Public comment response

Re: Project File #608020 Cape Cod Bridges Project

The Draft Environmental Impact Report Section 4.3.2 illustrates and describes the Bourne South Quadrant's shared use facility as follows:

Figure 2 - Location of proposed overpass versus existing path plan

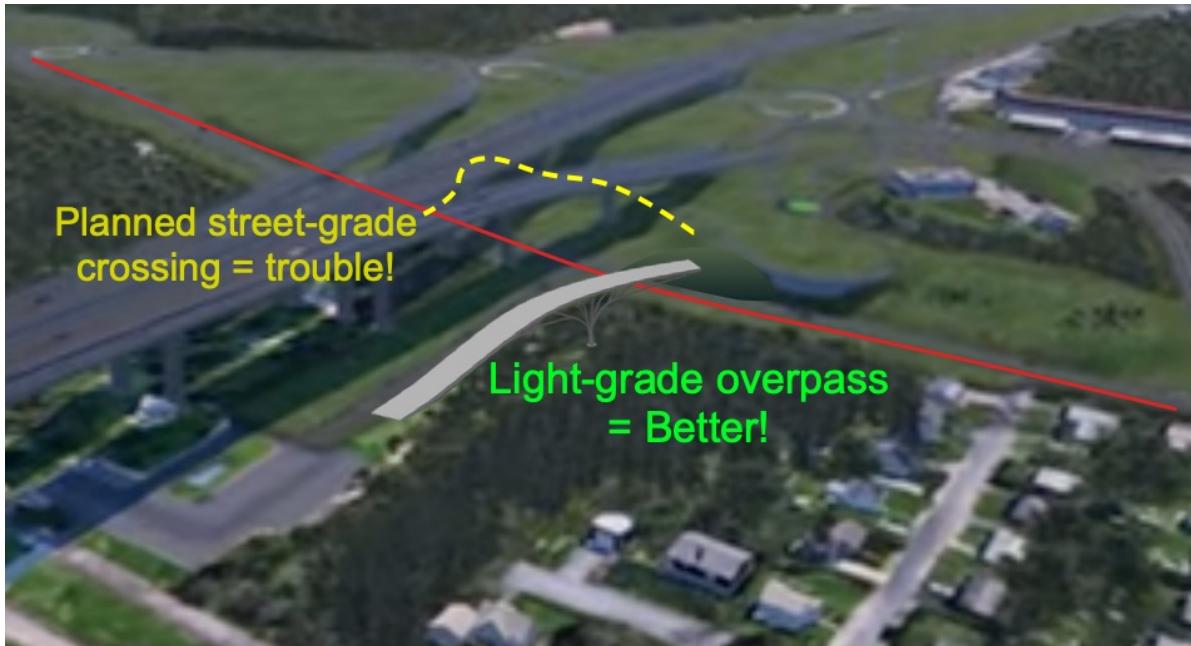
A light, ramped, grade-separated bike & walker overpass is a simple cost-effective solution that **eliminates the issue entirely** by leveraging the existing site elevation, the already-planned retaining wall, and already-available land. Figure 2 illustrates this.

- **Simplifies canal bike path connection.** The overpass can safely exit near most users' destination - the bike path.
- **Eliminates vehicle-human conflict.** Period. The overpass entirely avoids the interaction between bikes & walkers, and eliminates driver interference.

Figure 3 - Descent Ramp into existing public property

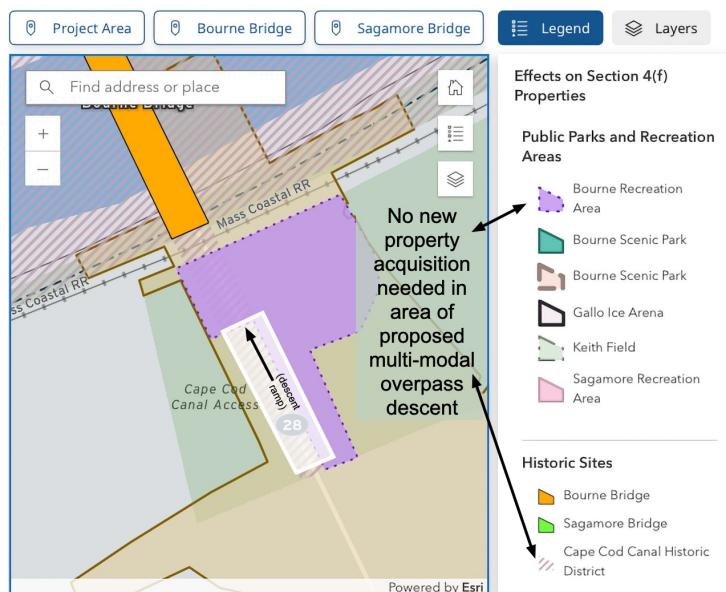
- **The change leverages planned structures.** A structural berm and major path descent are already included in the current plan; these elements can be reworked to form the southerly approach to the overpass. The northerly descent can be accommodated by a light, non-vehicular structure. A preliminary examination by project engineers indicates that replacing the planned path with an overpass is feasible.²
- **No new property required.** The northern side of the overpass, which constitutes the descent over grade, can descend into the existing Bourne Recreation Area and Cape Cod Canal District property. No property taking is required. See rough placement illustrated in Figures 3 & 4.
